CHANGE ORDER

CHANGE ORDER NUMBER
3
4/18/2022
Page 1 of 10

<input checked="" type="checkbox"/> ORDERED BY ENGINEER UNDER SECTION 1-04.4 OF THE STANDARD SPECIFICATIONS. <input type="checkbox"/> CHANGE PROPOSED BY CONTRACTOR.	PROJECT IDENTIFICATION PROJECT NAME: North Creek Trail Phase 1 – SR524 to Sprague Drive PROJECT NUMBER: RC1776, RR6318, RR6323, RR6319, RC1798
CONTRACTOR ENDORSEMENT: <div style="display: flex; justify-content: space-between;"> SIGNATURE DATE </div> <hr/> <div style="display: flex; justify-content: space-between;"> PRINT NAME TITLE </div>	CONTRACTOR: Rodarte Construction, Inc. ADDRESS: 17 East Valley Hwy E Auburn, WA. 98092

This Change Order compensates the Contractor for added work required to grind and pave a full-width HMA overlay on Filbert Drive and Winesap Road adjacent to the North Creek Trail Phase 1 Project.

REFERENCE SHEET NO. CH08
SHEET 131 OF 171 SHEETS

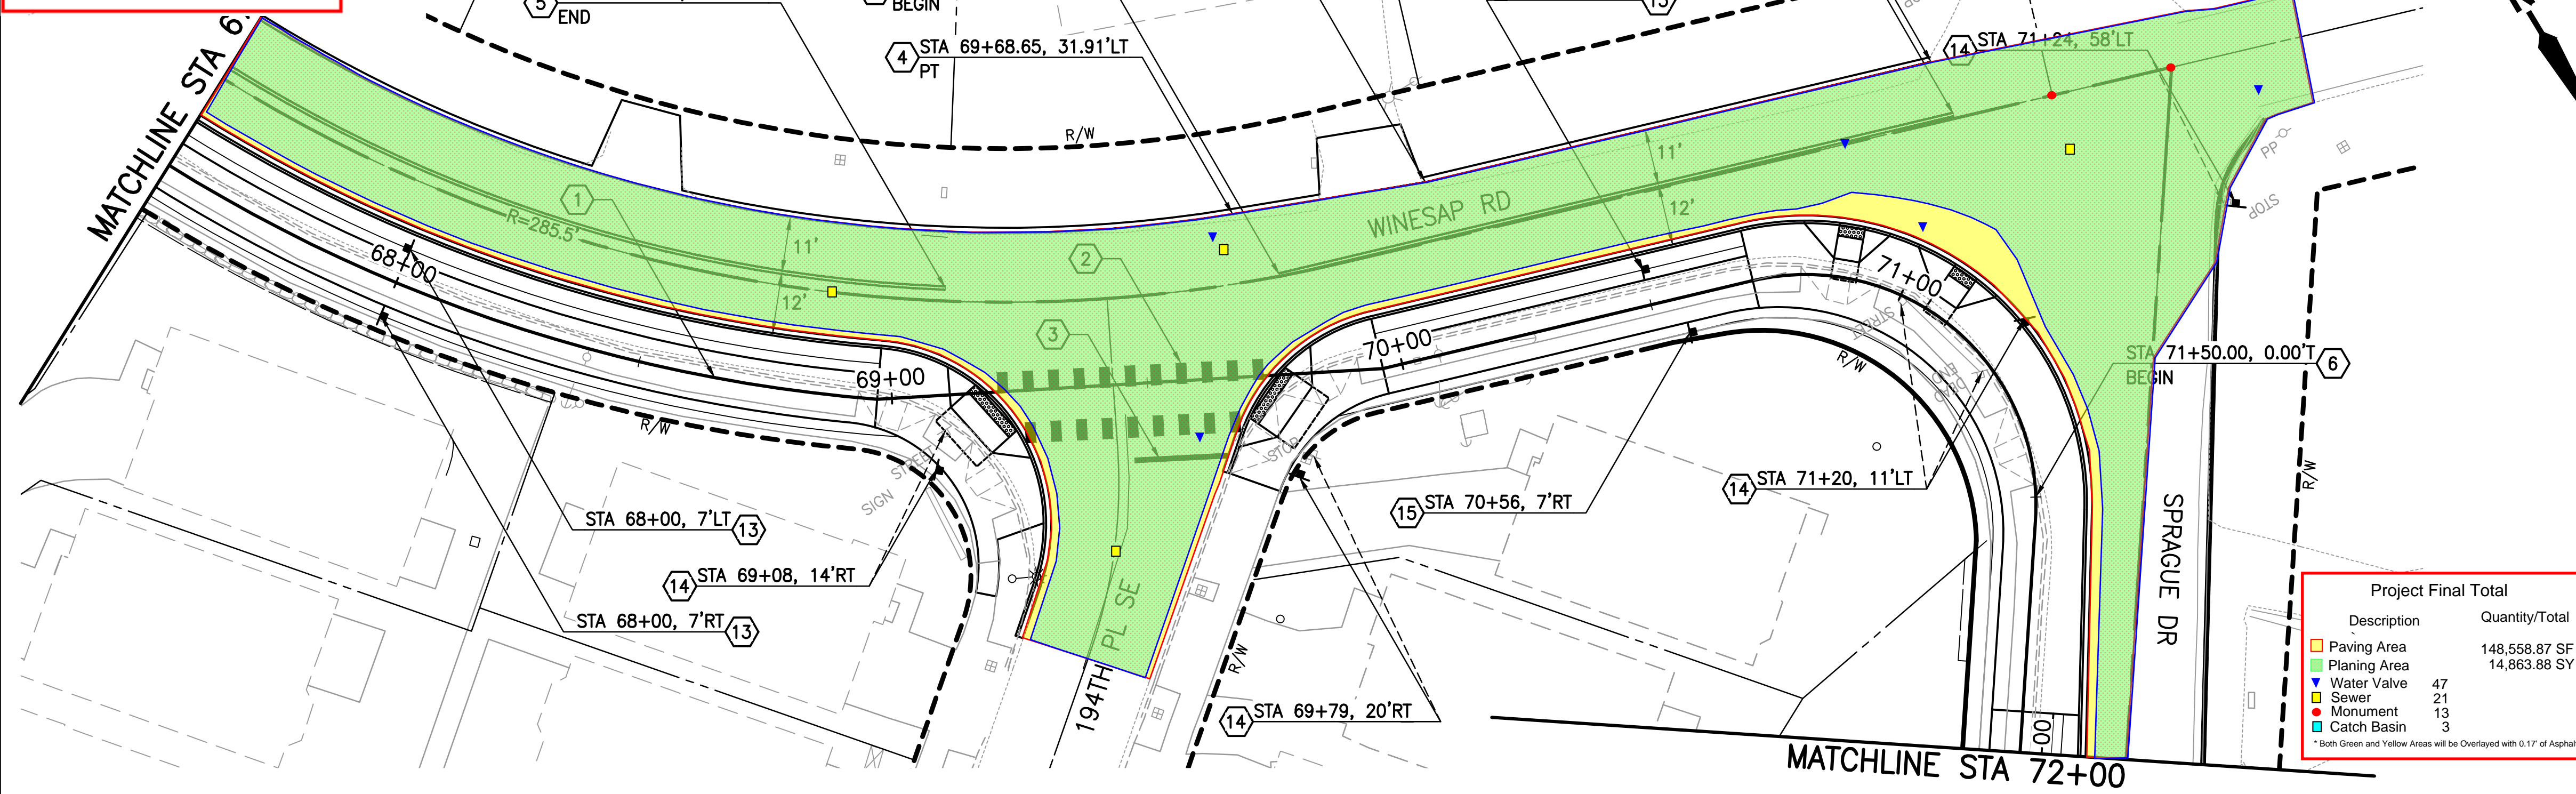
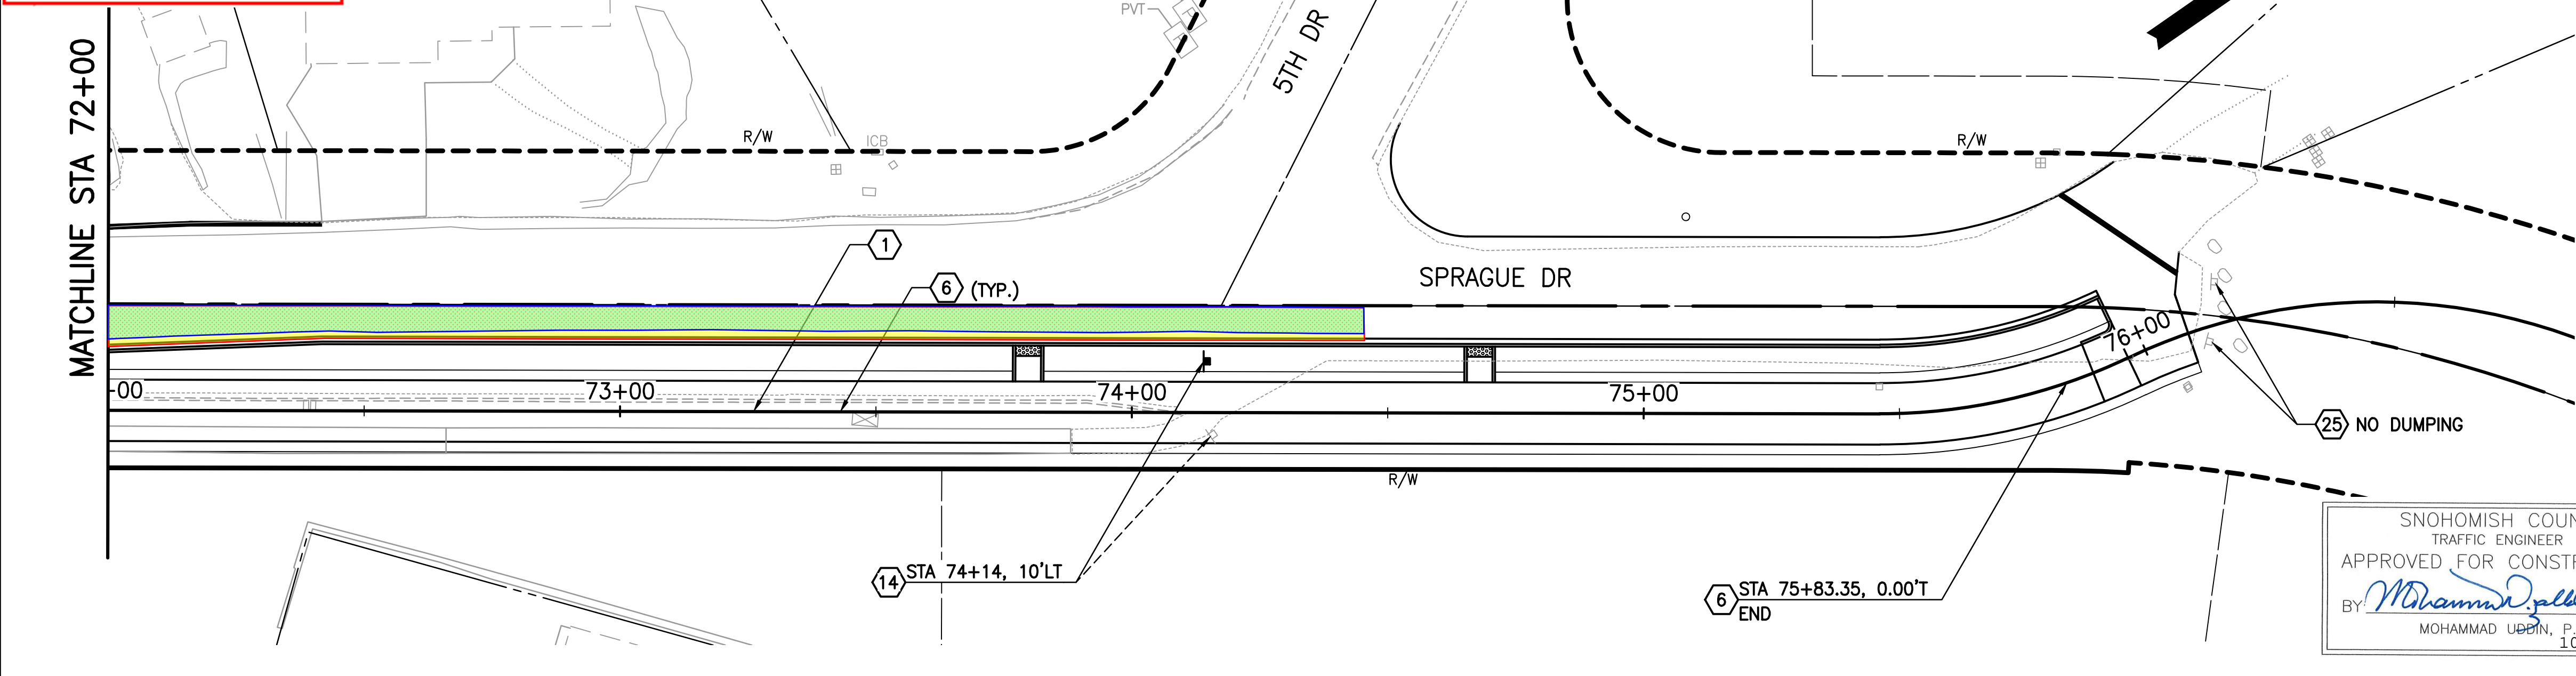
Legend This Section 67+50 - 72+00

Description	Quantity/Total
Paving Area	14,571.06 SF
Planing Area	1,515.36 SY
Water Valve	5
Sewer	4
Monument	2
Catch Basin	0

* Both Green and Yellow Areas will be Overlayed with 0.17" of Asphalt

Legend This Section 72+00 - 74+50

Description	Quantity/Total
Paving Area	1,592.92 SF
Planing Area	138.62 SY
Water Valve	0
Sewer	0
Monument	0
Catch Basin	0

* Both Green and Yellow Areas will be Overlayed with 0.17" of Asphalt
